Economic Commission for Europe**Inland Transport Committee****World Forum for Harmonization of Vehicle Regulations****Working Party on General Safety Provisions****100th session**

Regulation No. 46 (Devices for indirect vision)**Proposal for 03 series of amendments to Regulation No. 46
(Devices for indirect vision)****Submitted by the expert from the Netherlands***

The text reproduced below was prepared by the informal group on camera-monitor systems to objectify the requirements for testing camera-monitor systems of class V and VI. It takes into account the comments received during the ninety ninth session of the Working Party on General Safety Provisions (GRSG) and corrects some typographical errors in ECE/TRANS/WP.29/GRSG/2010/21. The modifications to the current text of the Regulation are marked in bold for new or strikethrough for deleted characters. The modifications to ECE/TRANS/WP.29/GRSG/2010/21 are shown in underlined characters.

Figure A
Diagram of the blooming measurement set-up.

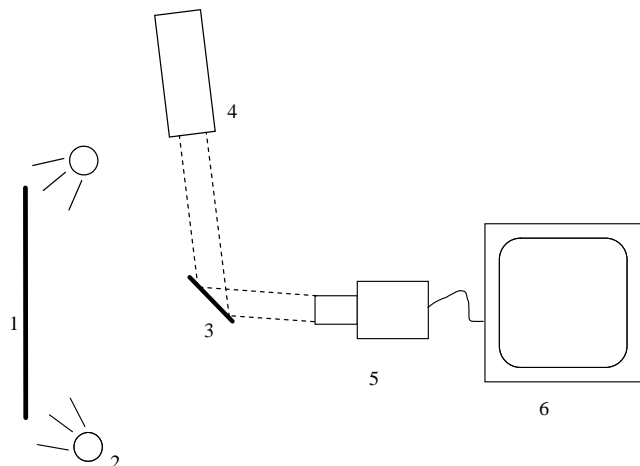
6.2.2.2.1.2. The camera shall be hit by a (simulated sun) light of 40 kLx, spanning an angle between 0.6 and 0.9 degrees with an elevation angle of 10 degrees (directly or indirectly via a mirror) removed from the optical axis of the sensor.

6.2.2.2.1.4. An example of the set-up is given in the figure A below.

9. As standard EN 12368 on traffic signal light cannot be applied directly to cameras, the test conditions for the blooming test, which simulates the influence of low sunlight on the performance of a camera, have been redefined in paragraphs 6.2.2.2.1 to 6.2.2.2.1.4. Also the area in which the contrast is below a certain value has been set on a maximum of 15 per cent of the image on a monitor. This value is based on the results of comparison test.

Figure 2
Typical relationship between the size of the triangle and the fraction of correct responses.

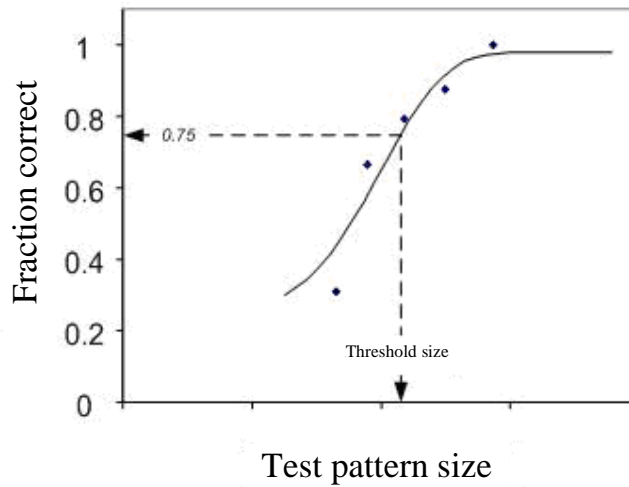
The Landolt C test can be used to determine the smallest discernable detail of the camera-monitor system. However, for sensor systems it is more suitable to use the TOD (Triangle Orientation Discrimination) method which is similar to the Landolt C method, but involves equilateral triangular test patterns. The Triangle Orientation Discrimination method is described in detail by Bijl & Valeton (1999), who provide practical guidelines on how to perform a TOD measurement. In the method, triangular test patterns (see Figure 1) are viewed through the viewing system under test. Each triangle can have one out of four possible orientations (apex up, left, right or down) and the observer indicates/guesses for each triangle its orientation. When this procedure is repeated for many (randomly oriented) triangles of different sizes the fraction of correct responses can be plotted (see Figure 2), and increases with test pattern size. The threshold is defined as the point at which the fraction correct crosses the 0.75 level and can be obtained by fitting a smooth function through the data (see Bijl & Valeton, 1999). Critical perception is reached when the critical object diameter equals two times the width of the triangle at threshold size. The smallest discernable detail (ω_c) is equal to 0.25 times the width of the triangle at threshold size. This means that, from the threshold triangle width w (in m) and the distance between test pattern and the camera D (in m) the smallest discernable detail ω_c (in arcmin) is calculated as follows:

15. The procedure for calculating the maximum detection distance on the basis of video lines (which is an oversimplified model that should no longer be used) has been replaced by a new procedure based on ophthalmologic tests like Landolt-C or TOD (Triangle Orientation Discrimination) test. This procedure guarantees that the displayed object has sufficient detail and size.
